ADDENDUM NO. 1

DATE: July 21, 2009

PROJECT: POLAR SHORES MODIFICATIONS
LAKE SUPERIOR ZOO

LOCATION PLAN

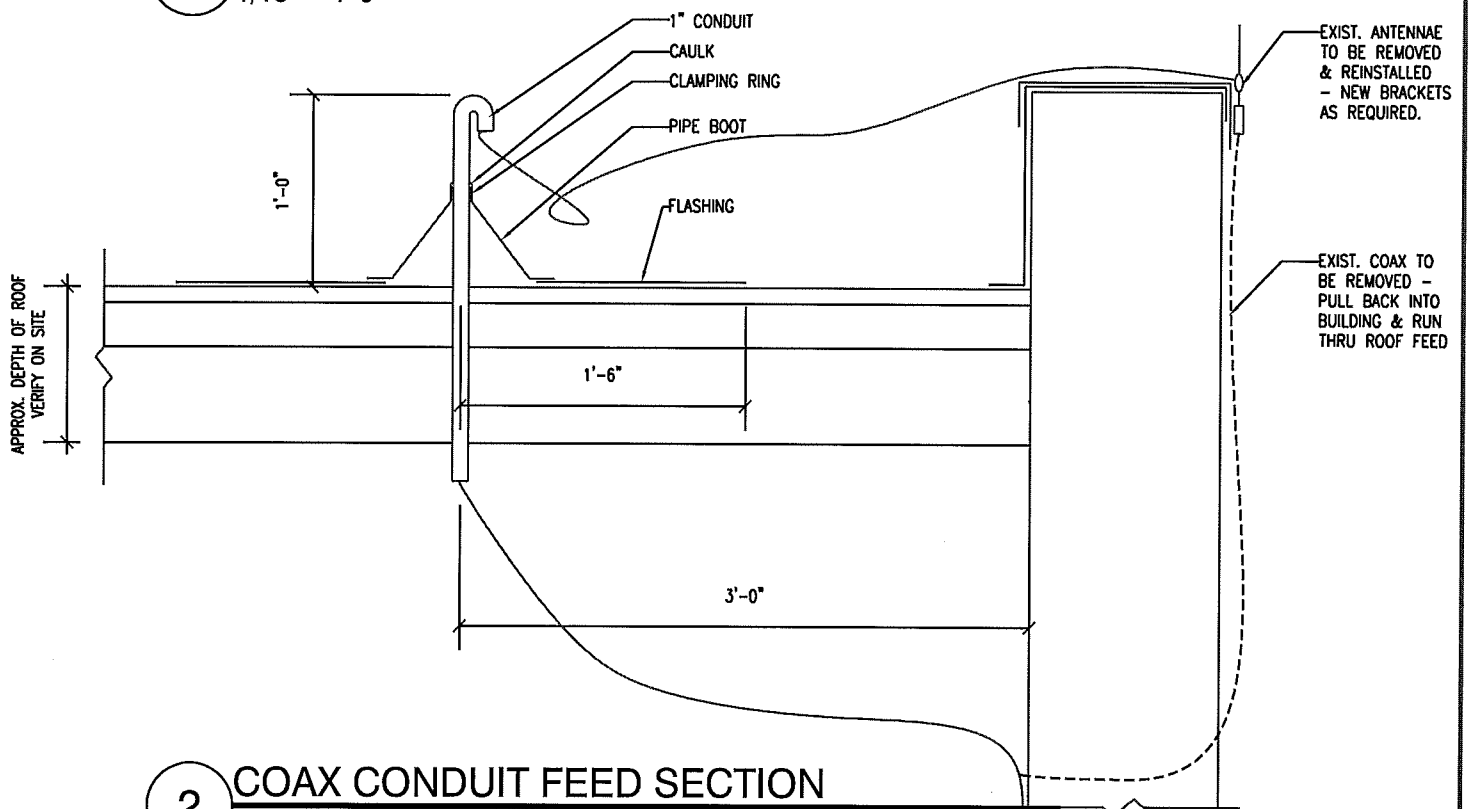
- A. First Floor – To the south of the existing switchboard, there is an existing spare fuse cabinet. Relocate cabinet to a nearby wall (as directed) and re-install, to make room for new Panel A.
- B. First Floor – An existing security system cable runs out of the building, through the existing glass block opening which will be enclosed by the new addition, to a roof-mounted antennae. Remove for construction of new roof assembly, re-install and re-connect after new construction is complete. See attached addendum drawing 1.

1 **2nd FLOOR ROOF ACCESS LOCATION PLAN**
 1/16" = 1'-0"

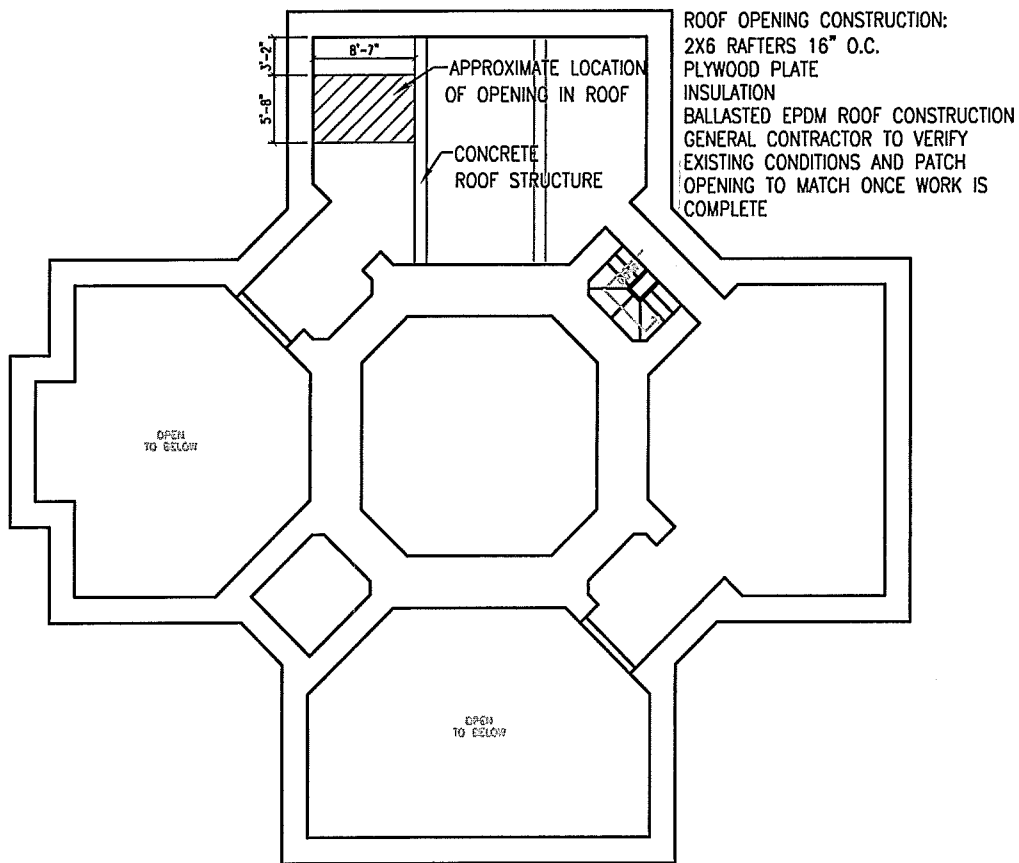
- A. For removal of existing boilers from 2nd floor (and installation of new), Contractor may open the existing roof above the existing boilers. Approx. location of opening in existing roof deck is indicated on attached addendum drawing 2. Otherwise boilers will need to be removed and installed through the existing opening between the 2nd floor boiler room and the open two-story space located to the southeast.

7 BOILER PIPING SCHEMATIC

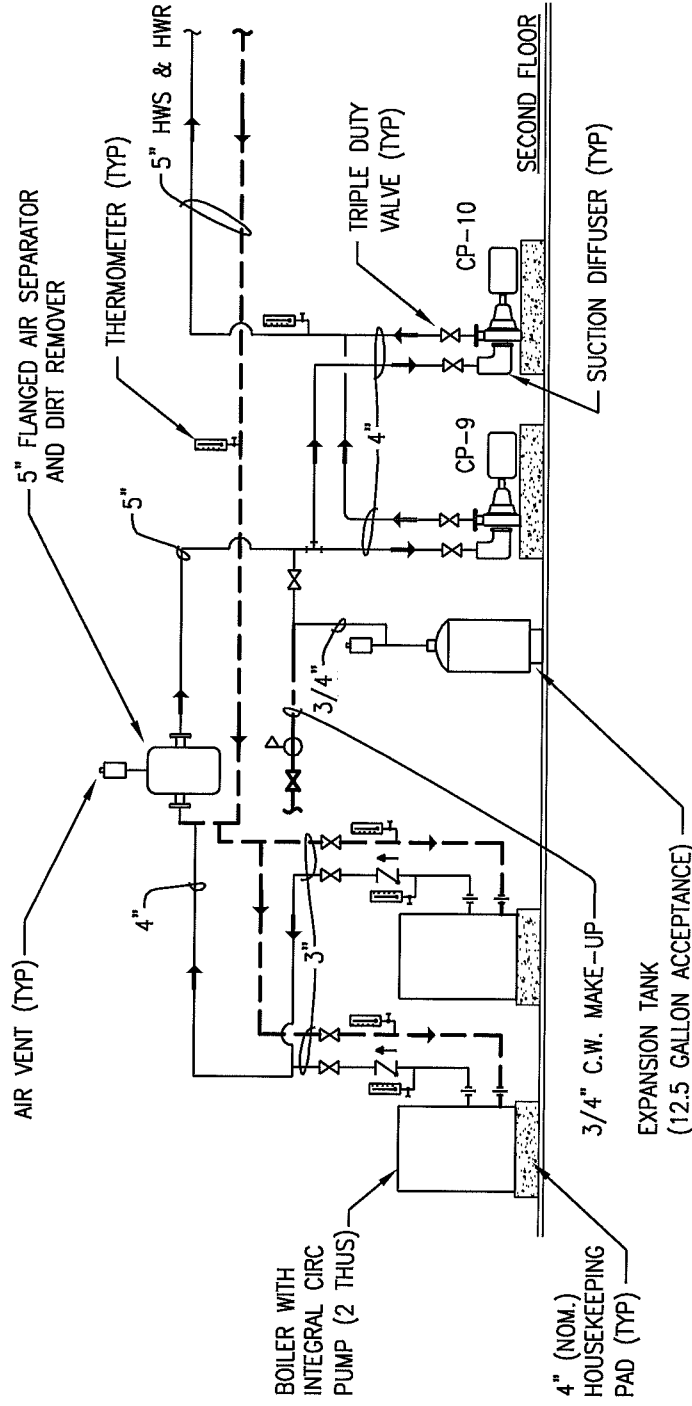
- A. Detail 3 – Add 3/4" cold water makeup connection (less meter) to the supply piping for systems serving Pools #5 & #6.
- B. Revise detail 7 – Boiler Piping Schematic as per the attached addendum drawing MA-1.
